TVA-BFN-TS-414 Supplement 2

**BROWNS FERRY NUCLEAR PLANT (BFN) - REDUCTION IN REQUESTED
EFFECTIVE FULL POWER YEARS (EFPY) FOR TECHNICAL SPECIFICATIONS
(TS) CHANGE NO. 414 - PRESSURE - TEMPERATURE (P-T) CURVE
UPDATE**

TENNESSEE VALLEY AUTHORITY
BROWNS FERRY NUCLEAR PLANT (BFN)
UNITS 2 AND 3

PROPOSED TECHNICAL SPECIFICATION (TS) CHANGE TS-414 SUPPLEMENT 2
MARKED PAGES

Figure 3.4.9-1
Pressure/Temperature Limits

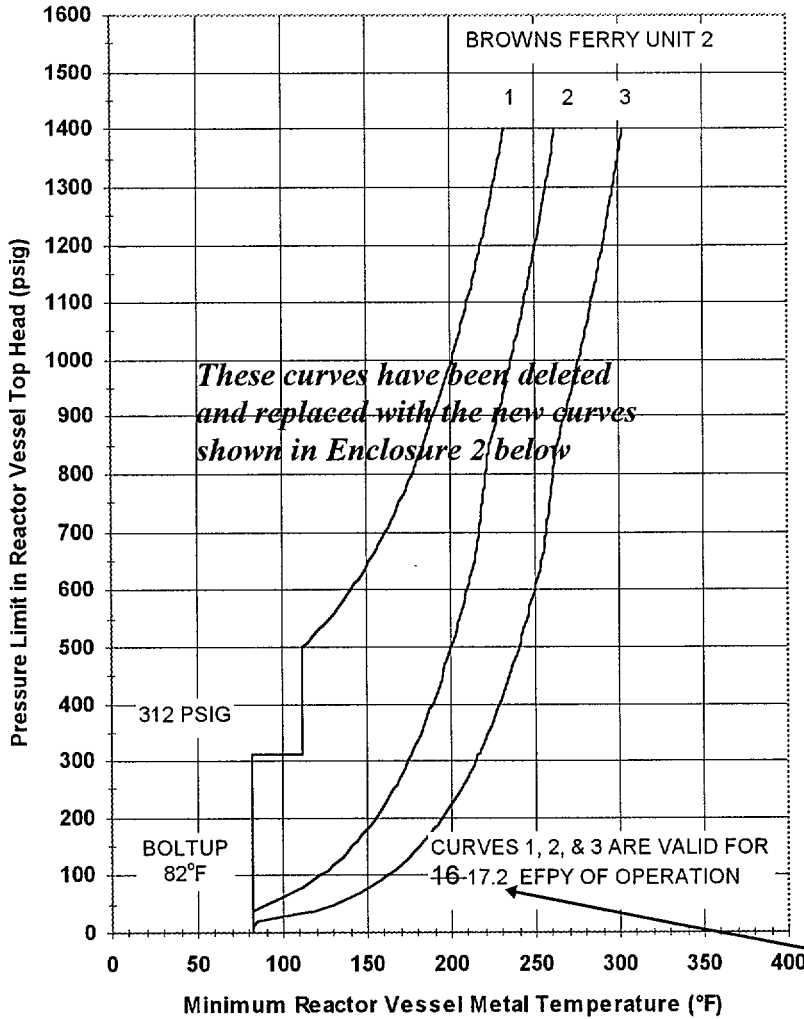
Added "ASME" for additional clarity in this note.

Notes
These curves include sufficient margin to provide protection against feedwater nozzle degradation. The curves allow for shifts in RT_{NDT} of the Reactor vessel beltline materials, in accordance with Reg. Guide 1.99, Rev. 2, to compensate for radiation embrittlement for ~~16~~ 17.2 EFPY.

The period of valid use of these curves has been changed from 16 to 17.2 EFPY.

**Figure 3.4.9-1
Pressure/Temperature Limits**

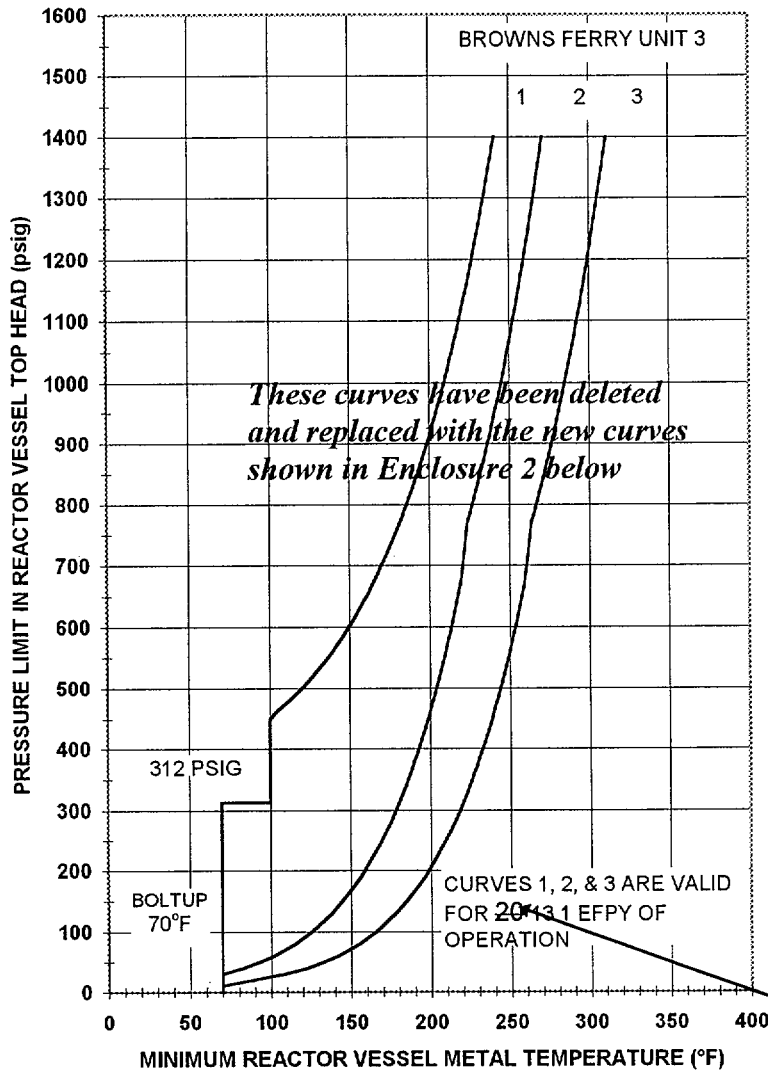
Added "ASME" for additional clarity in this note.

Notes
These curves include sufficient margin to provide protection against feedwater nozzle degradation. The curves allow for shifts in RT_{NDT} of the Reactor vessel beltline materials, in accordance with Reg. Guide 1.99, Rev. 2, to compensate for radiation embrittlement for 20/13.1 EFPY.

The period of valid use of these curves has been changed from 20 to 13.1 EFPY.
